Technical News

Issue 151

November 2013

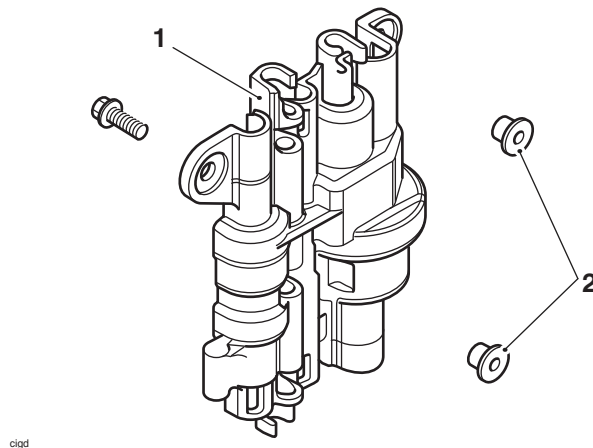
Flanged sleeves have been introduced to the crankcase harness guide on the above models from engine number 627230. To facilitate the use of the flanged sleeves, the mounting holes in the harness guide have been enlarged.

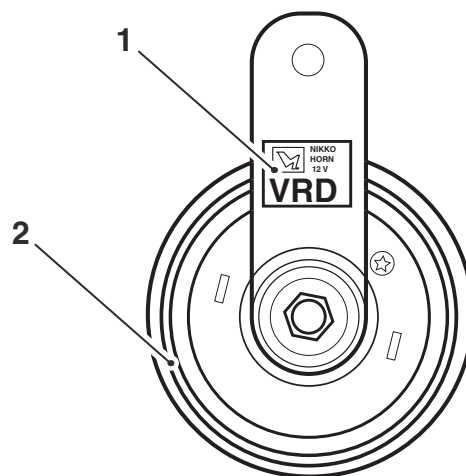
A revised horn has been fitted to the above models. The revised horn's internal circuit is fitted with a suppressor to eliminate any possible interruption to the audio playback via the USB connection during operation. The revised horn is identified by the letters **VRD** included in the part number label.

Description: Regulator/Rectifier Spares Kit

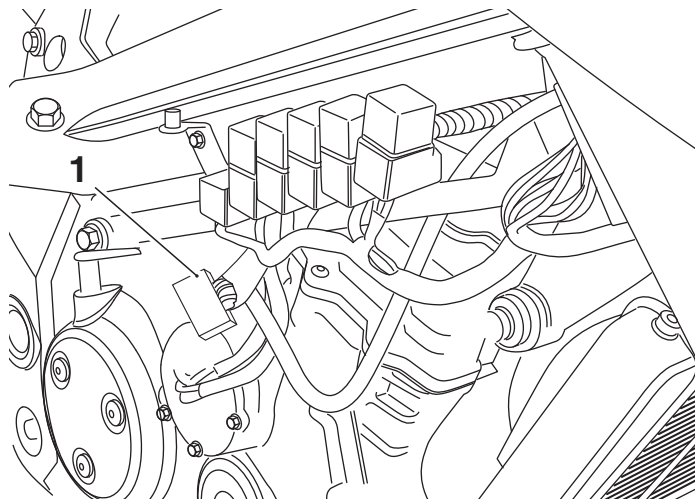
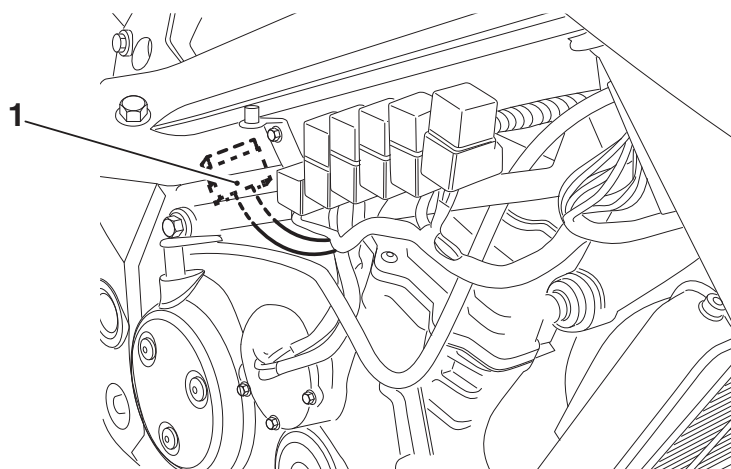
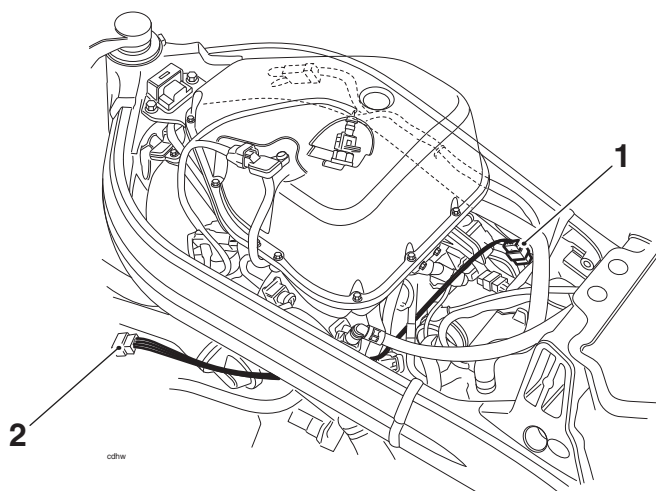
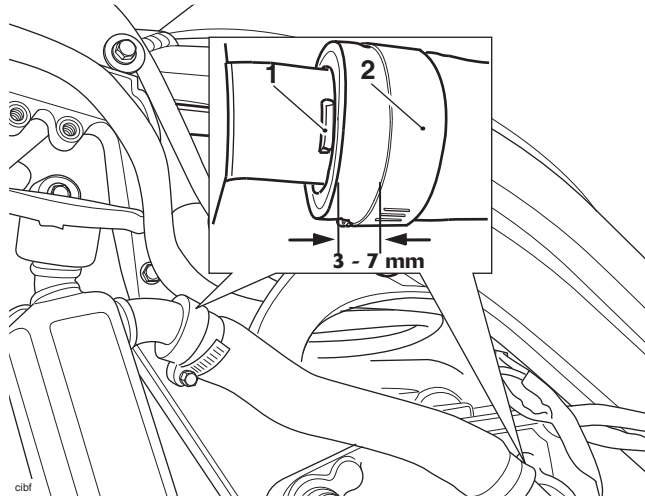
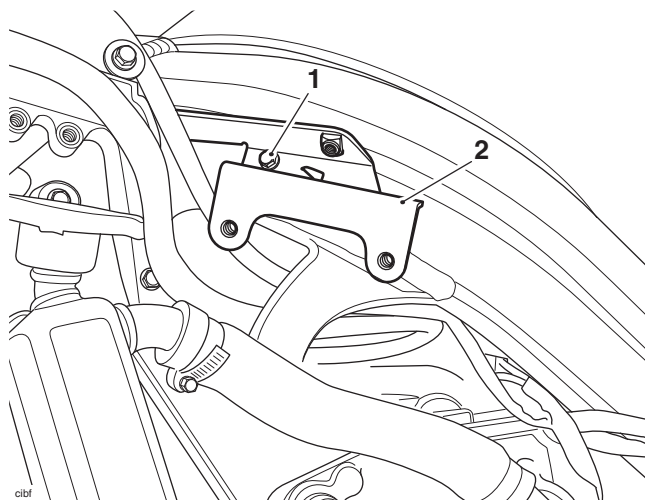
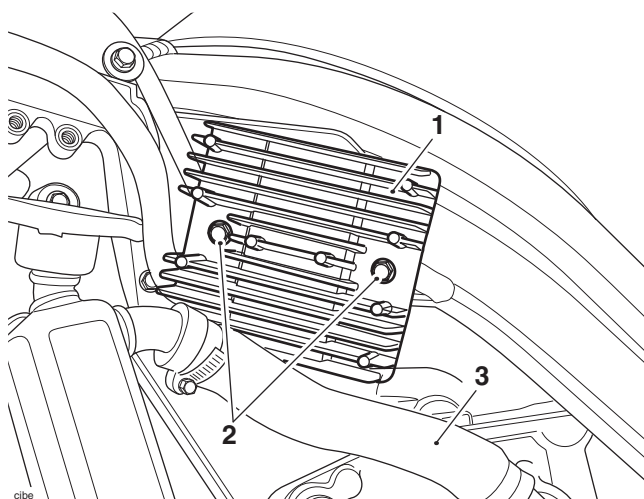
A new regulator/rectifier has been introduced on the above models and is retrofittable as a kit.

The regulator/rectifier spares kit allows the regulator/rectifier to be fitted to the left hand side of the frame adjacent to the radiator filler cap.

Description: New Footrest Assemblies Incorporating Replaceable Bank Angle Indicators

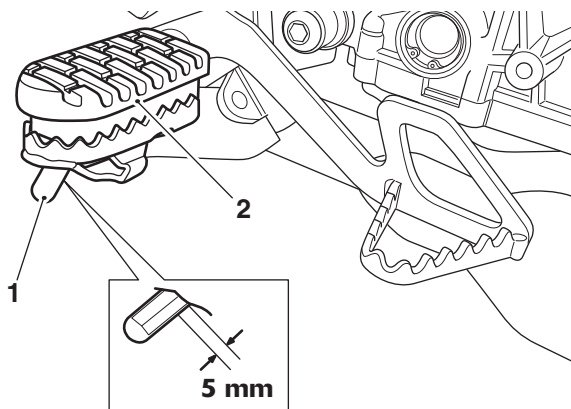
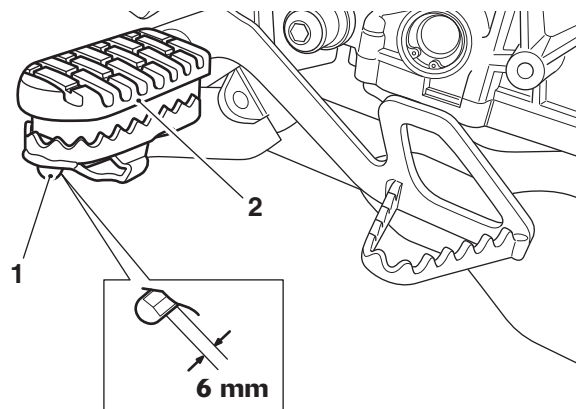
New front footrest assemblies which incorporate replaceable bank angle indicators will shortly be introduced on the above models.

- **Inspect the bank angle indicators on the rider's footrests for wear. The bank angle indicator wear limits are as follows:**
- Tiger 800 and Tiger 800 ABS - The bank angle indicator is worn out when **5 mm** of the indicator remains.
- Tiger 800XC and Tiger 800XC ABS - The bank angle indicator is worn out when **6 mm** of the indicator remains.

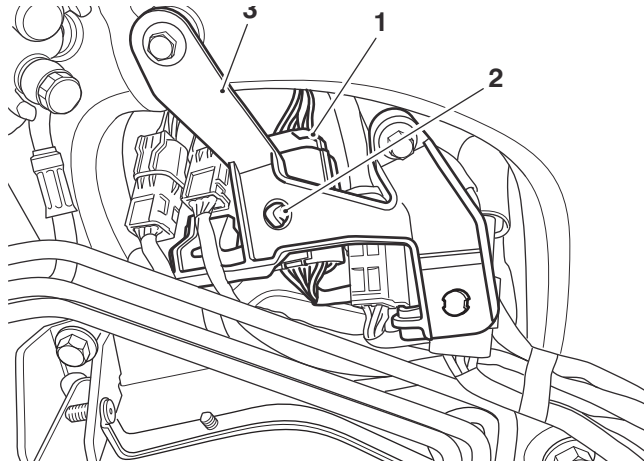
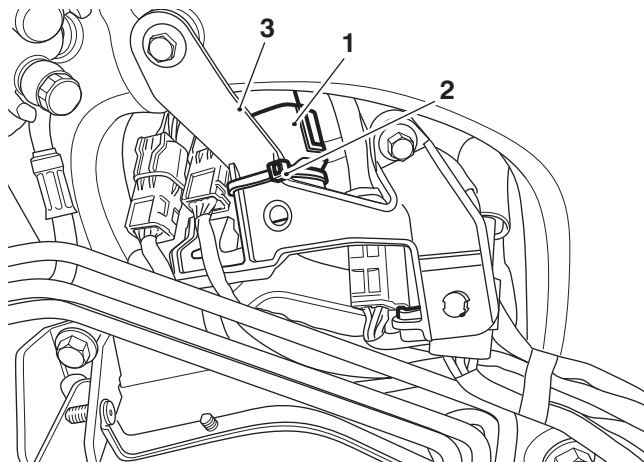
Internal investigations have identified that the connector terminals of the switch harness may be affected by tension when the handlebars are turned from lock to lock, affecting the operation of the starter motor. If for any reason the fuel tank is removed i.e a full service or component replacement that requires the fuel tank removing, dealers are requested to remove the connector from its bracket and reposition it as described below:

1. Disconnect the right hand switch housing connector from its bracket.

2. Remove and discard the fir tree clip from the connector.
3. Position the main harness electrical connector until the narrow part is adjacent to the bend in the bracket and secure using a cable tie.

Description: Alternator Cover

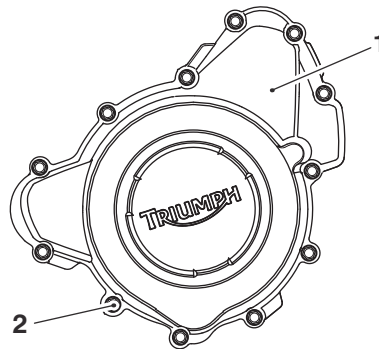
The torque figure for the fixings securing the alternator cover has changed to **10 Nm** on the above models. The tightening sequence for these fixings is as described in Technical News 131 issued January 2012.

- If removed for any reason the fixings must be replaced.
- Models already in service need not be re-tightened unless the fixings have been loosened or removed.

Description: Clutch Cover Protector

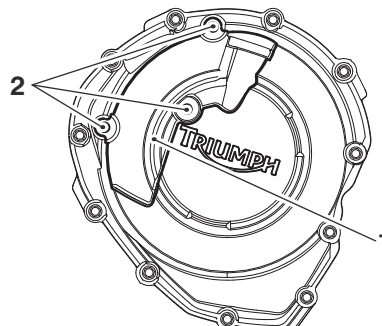
The torque figure for the fixings securing the clutch cover protector has changed to **5 Nm** on the above models.

Description: Engine Mounting Washers

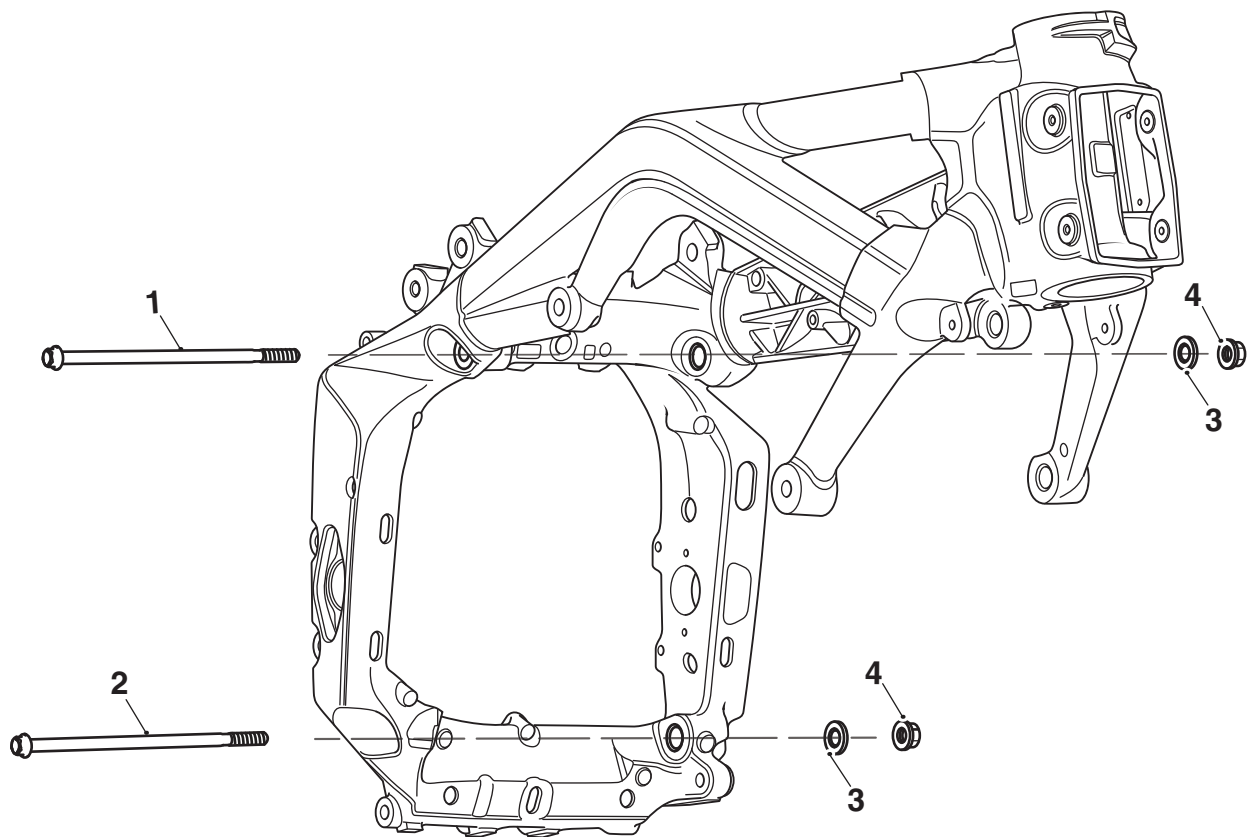
A washer is now fitted between the lock nut and the frame adjuster. To allow for the washer, replacement longer bolts are fitted from the right hand side of the motorcycle as shown below. The washers are fitted between the frame adjuster and the lock nuts to reduce contact stress between the lock nut and frame during final tightening.
